# NOTICE OF DECISION TO APPROVE AMENDMENTS TO PROPOSAL DURING ASSESSMENT

Ammonia Plant, Murujuga (Burrup Peninsula) – Renewable Hydrogen Project Assessment No. 2274

# Summary of reasons for decision – request to amend a referred proposal under s43A of the *Environmental Protection Act 1986*

Figure 1: Amended proposal – Development envelope and disturbance footprint

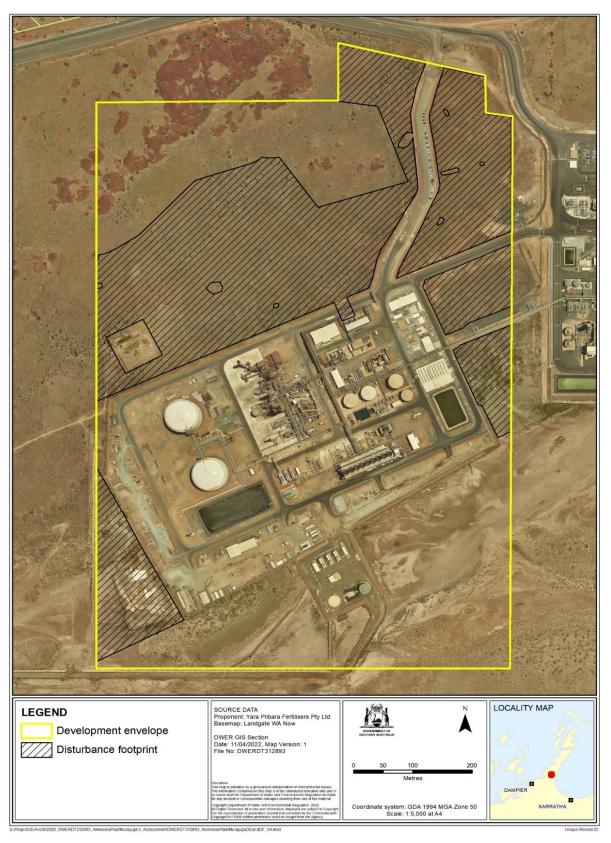
- Reduce the proposal's disturbance footprint by:
  - excluding three Aboriginal heritage sites from the disturbance footprint
  - establishing a 50 m buffer zone between the northern boundary of the disturbance footprint and exposed granophyre boulders that are likely to feature engravings
- Establish a 50 m buffer zone around a men-only site located 20 m outside of the disturbance footprint
- Construct and maintain an access track between Sites 20897 and 9838

The configuration of the development envelope and disturbance footprint for the amended proposal is shown in Figure 1 in Attachment 2.

Amendment sought		Changes to environmental impacts	
distu - e	rbance footprint by: excluding three Aboriginal eritage sites from the	The amended proposal will reduce the size of the disturbance footprint from 24.77 ha to 22.94 ha. Clearing of vegetation will reduce from 23.03 ha to 21.23 ha.	
d - e zo b	disturbance footprint  - establishing a 50 m buffer zone between the northern boundary of the disturbance footprint and exposed granophyre boulders that are	Therefore, there will be decreased impacts to flora and vegetation, terrestrial fauna habitat, and Aboriginal heritage sites and cultural values.  The amended proposal is likely to be consistent with the relevant EPA environmental factor objectives.	
• Estab	kely to feature engravings  plish a 50 m buffer zone  nd a men-only site located  n outside of the disturbance  print		
	truct and maintain an access between Sites 20897 and

Amendment(s) to the proposal as set out in Attachment 1 and Attachment 2 are approved.
